Interbay Apartments

FISH
MACKAY
ARCHITECTS LLC

Early Design Guidance

February 16, 2011
DPD Project# 3010370

VIEW FROM QUEEN ANNE HILL LOOKING WEST

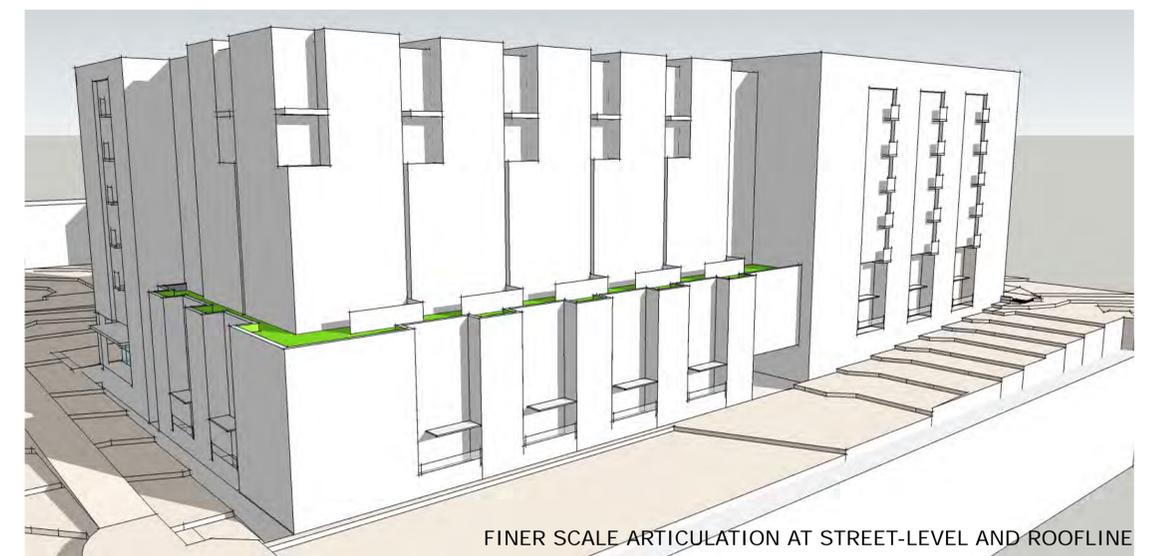
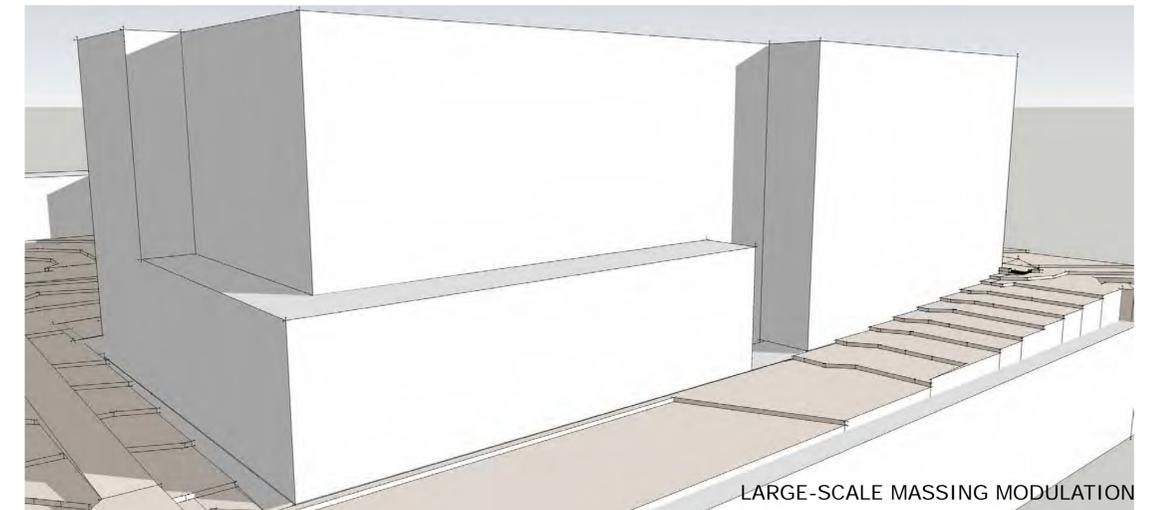
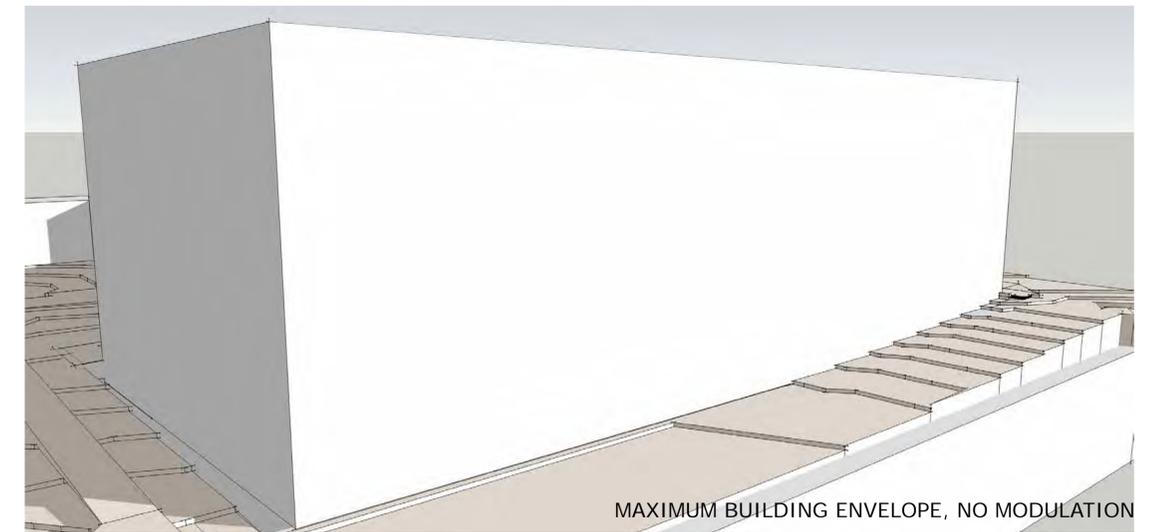
The Board asked the applicant to consider different materials and additions, such as raised parapets, elevator and mechanical equipment, and a green roof to help break down the appearance of mass from neighboring buildings and the nearby hills. The roof (s) should be thought of as a separate façade in need of careful design attention.

The proposed building will feature major articulations and setbacks to bring down the overall scale, as well as finer-scale articulations to provide visual interest and a human scale. Roof lines are varied as well to mitigate the large footprint of the building. Materials and colors correspond to articulations on the facades and contribute further to breaking the mass of the building down to create a sense of several different but cohesive buildings.

E. Landscaping

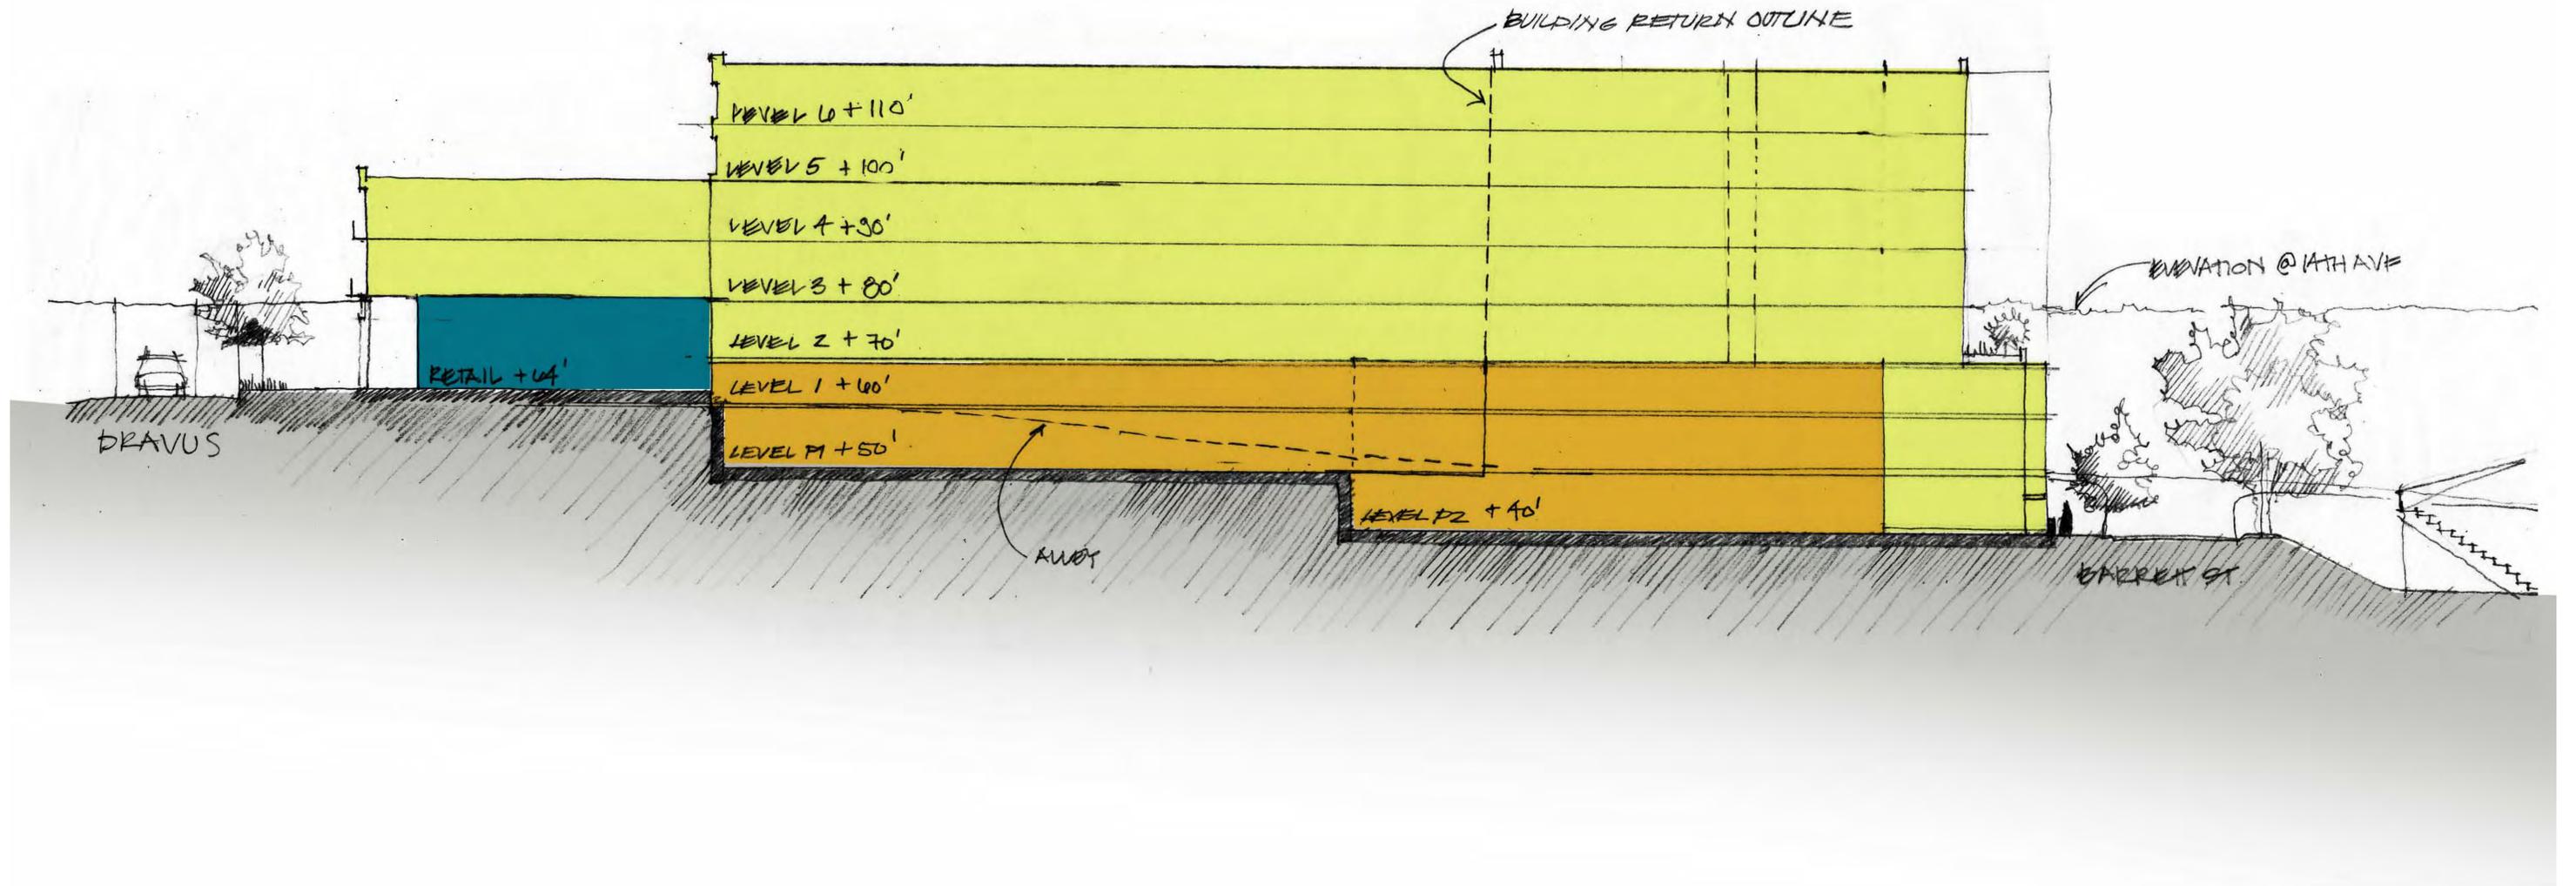
E-2 Landscaping to Enhance the Building and/or Site. Landscaping, including living plant material, special pavements, trellises, screen walls, planters, site furniture and similar features should be appropriately incorporated into the design to enhance the project.

The proposed building and surrounding streetscape will incorporate landscape features intended to enhance the pedestrian experience, screen walls without openings, and collect stormwater. The priority will be those areas most used by pedestrians and visible from the street.
